**VWP 19-2036 - Wegmans Distribution Center - Request for Additional Information**1 message

RE: Joint Permit Application Number 19-2036  
Wegmans Distribution Center, Hanover County, Virginia  
Additional Information Request Letter

Re: Joint Permit Application Number 19-2036, Wegmans Distribution Center, Hanover County, Virginia, Additional Information Request Letter (dated 9/18/2020).

Re: Joint Permit Application Number 19-2036, Wegmans Distribution Center, Hanover County, Virginia, Additional Information Request Letter (dated 9/24/2020).

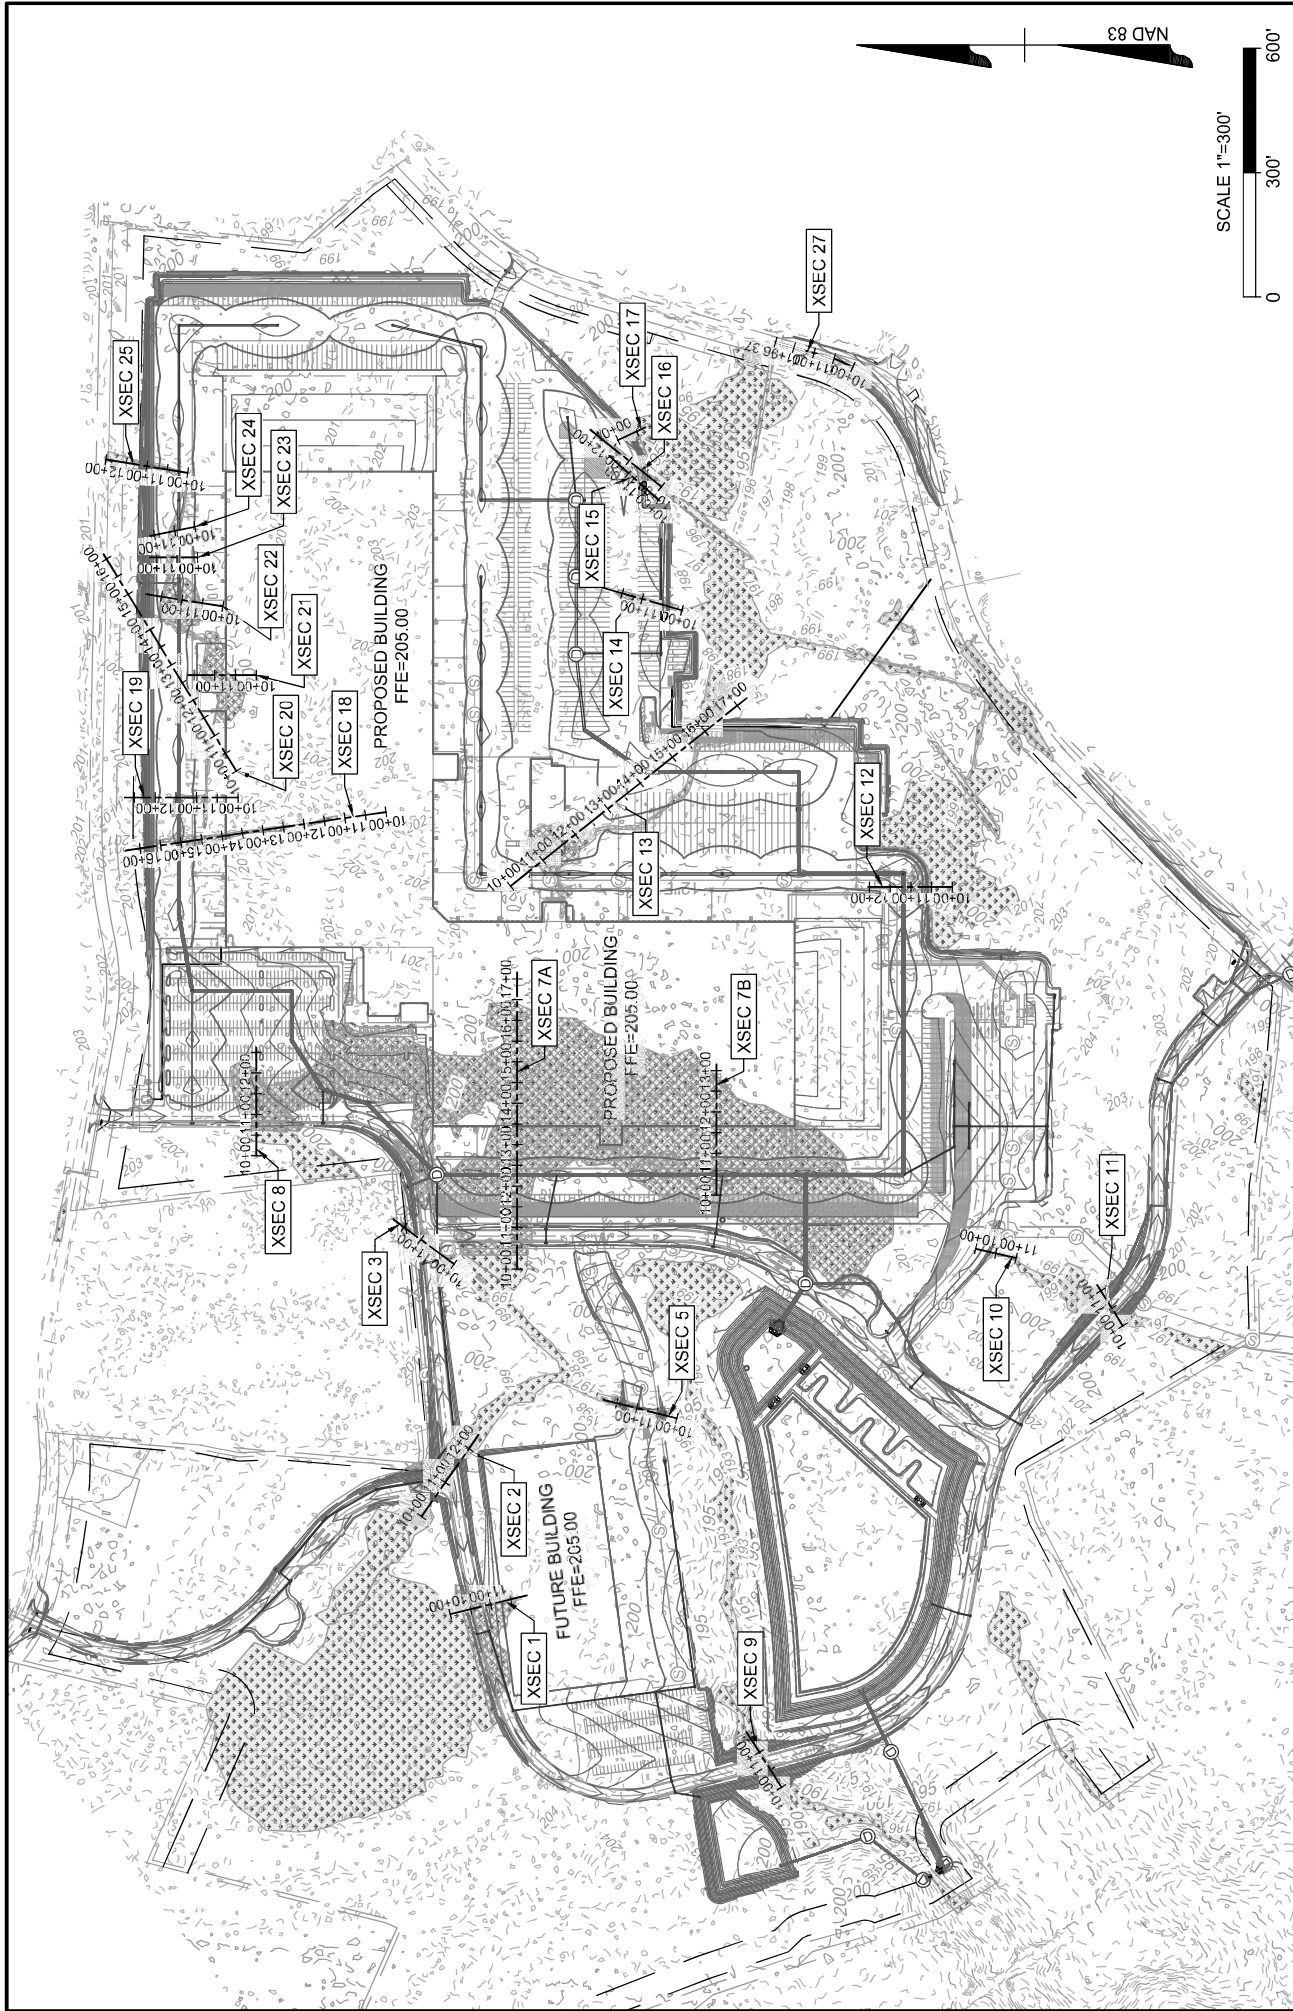
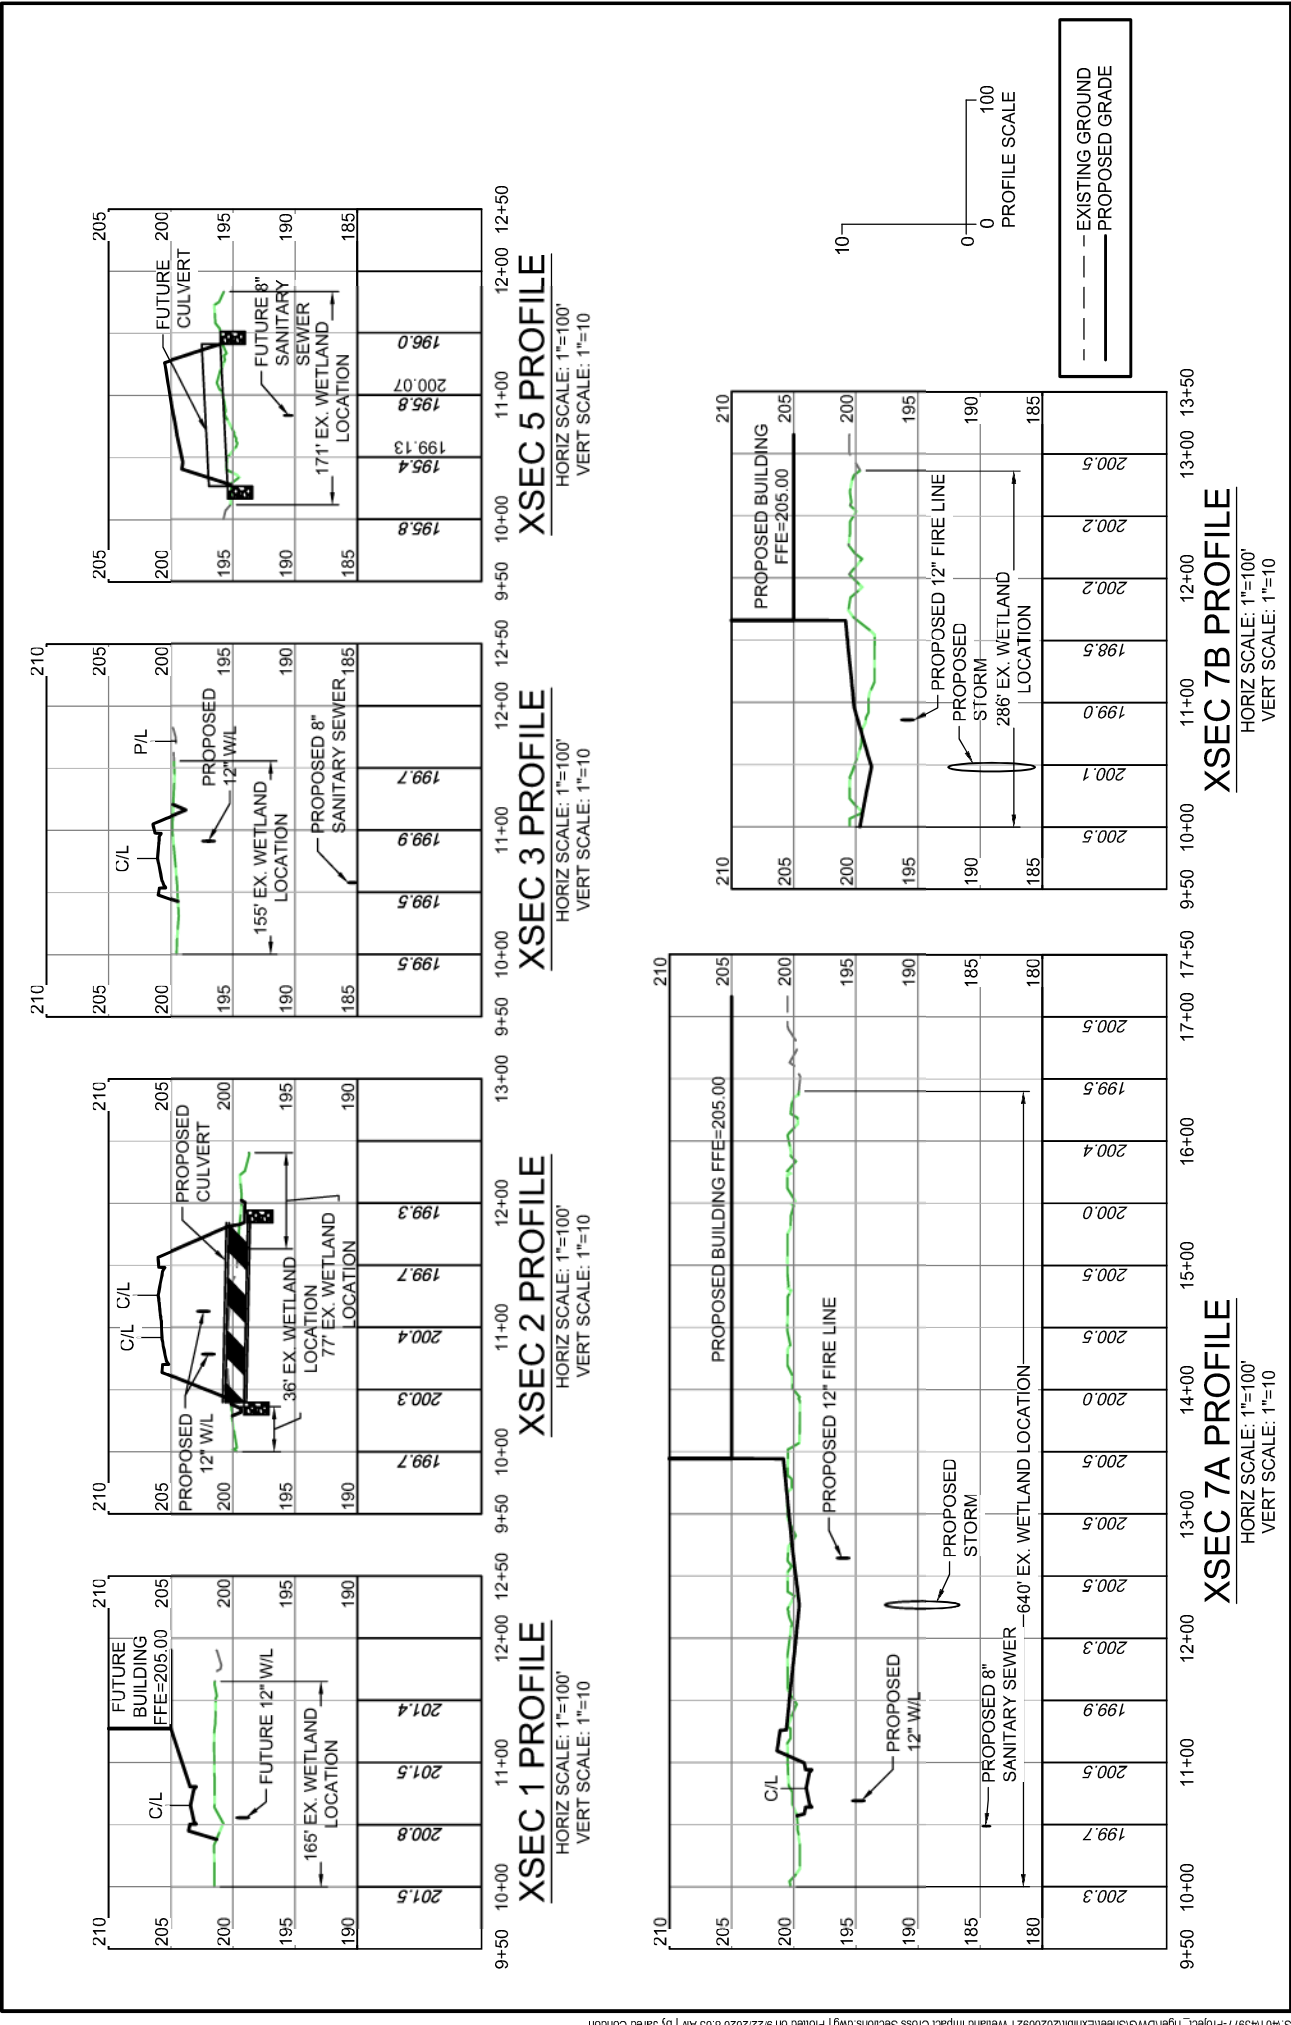
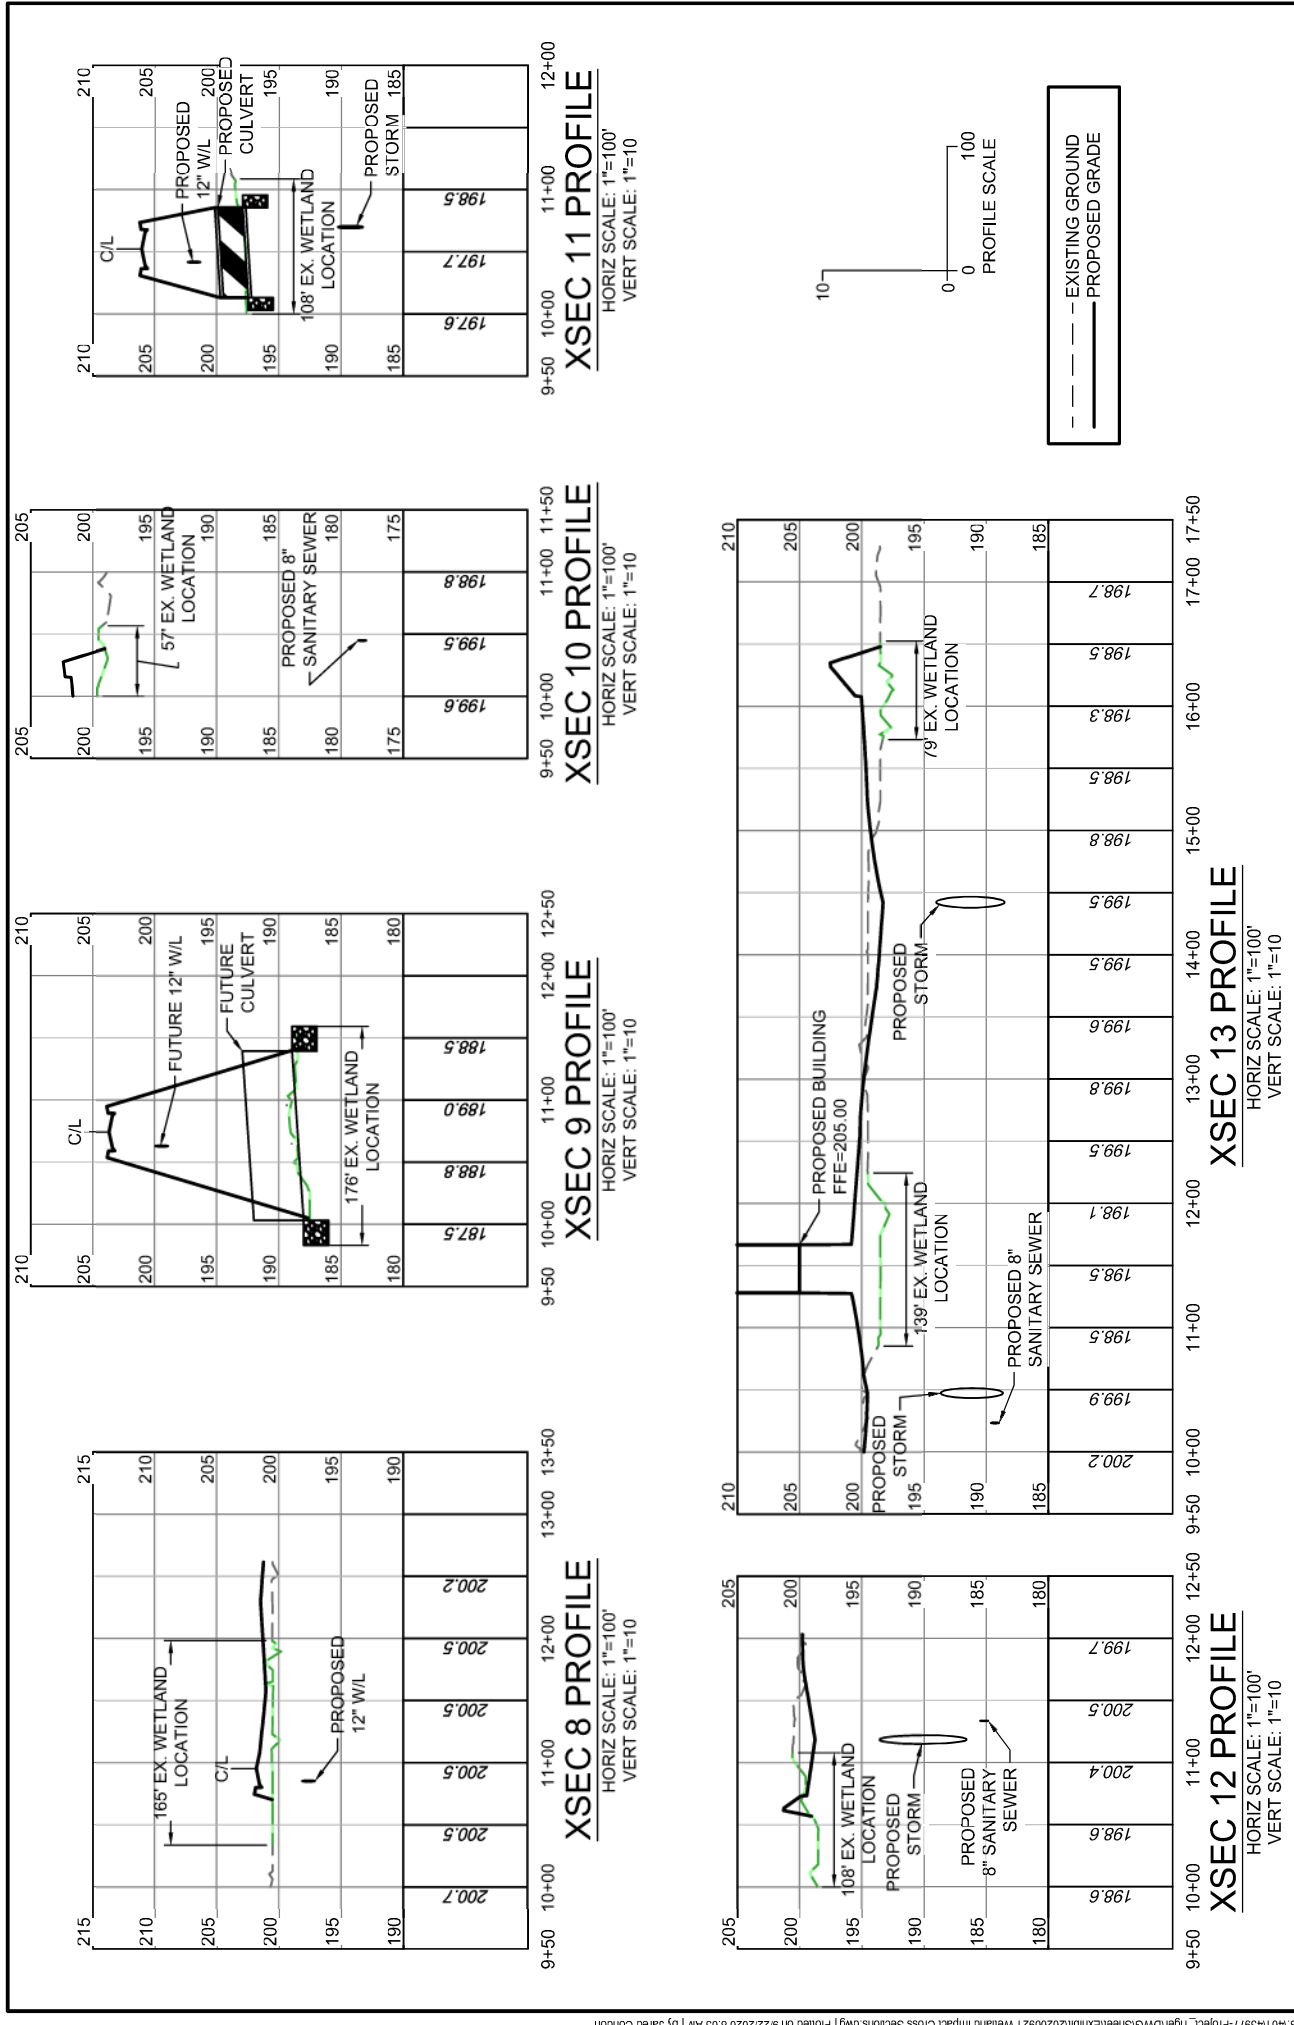
7. In accordance with 9 VAC 25-210-80 B 1.h, please provide an analysis demonstrating how secondary impacts will be avoided to remaining surface waters adjacent to Impacts 12, 13, 16, 17, and 20. Additionally, please explain the reasoning for all newly proposed secondary impacts identified on the September 8, 2020 Impact Map.

11. In accordance with 9 VAC 25-210-80 B 1.j, please provide revised cross-sectional drawings for each proposed impact area where surface water impacts have changed or where design of infrastructure has changed in the impact areas.

It has been determined that unavoidable secondary impacts to the ditch at impact location 20 will occur. An additional 416 sq. ft. of impacts will occur to that feature, causing a total of 4,023 sq. ft. of impacts to 20.

Please see attached updated impacts map.

Please see attached cross-sectional drawings.

**WETLANDS AND WATERS IMPACTS MAP**

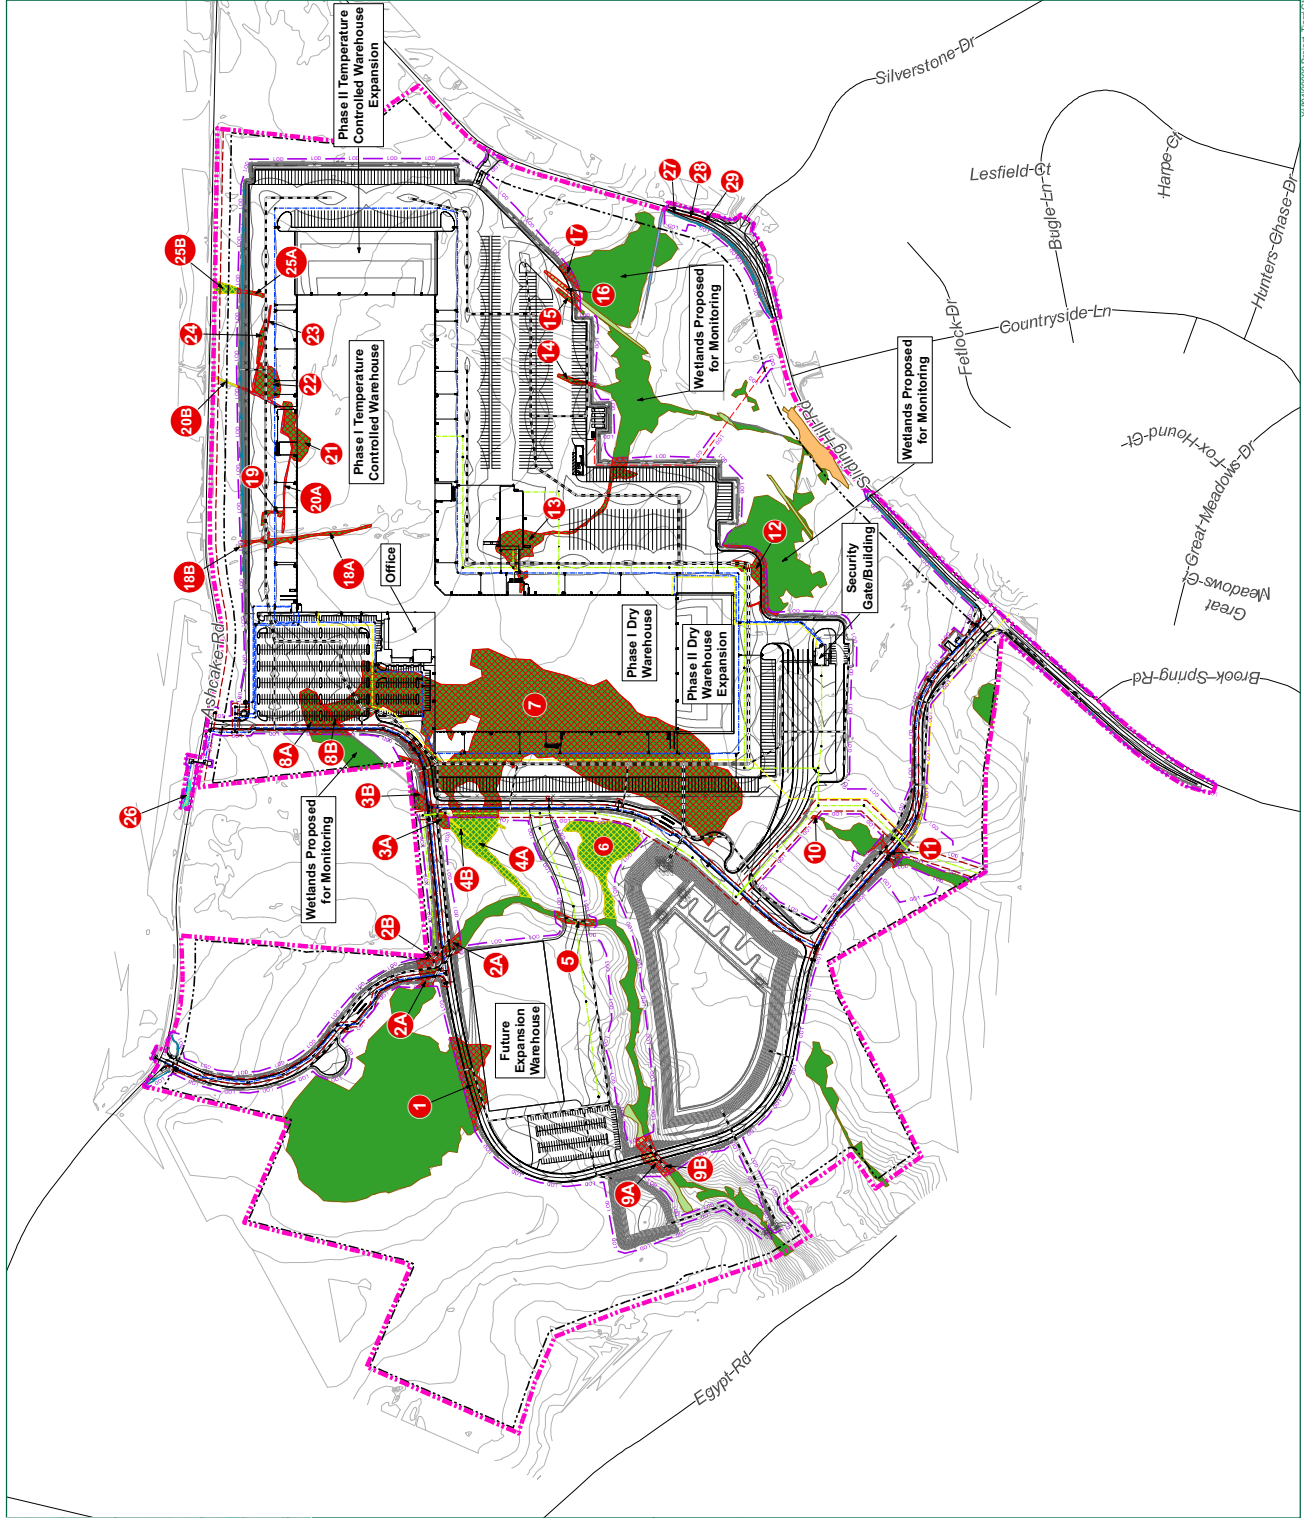
9. In accordance with 9 VAC 25-210-80 B 1.i, the limits of disturbance (LOD) appears to have changed in multiple areas on the September 8, 2020 Impact Map. Please identify all areas where the LOD has changed and explain these changes. If any type of proposed grading and/or structures are proposed within the areas where the LOD has changed, please depict all proposed contours and structures.

Additionally, please ensure that the entire LOD is included within the Project Study Limits.

The changes in LOD are due to offsite improvements associated with adjacent roadways and utility tie ins. Those areas have been updated on the impacts map (see attached).
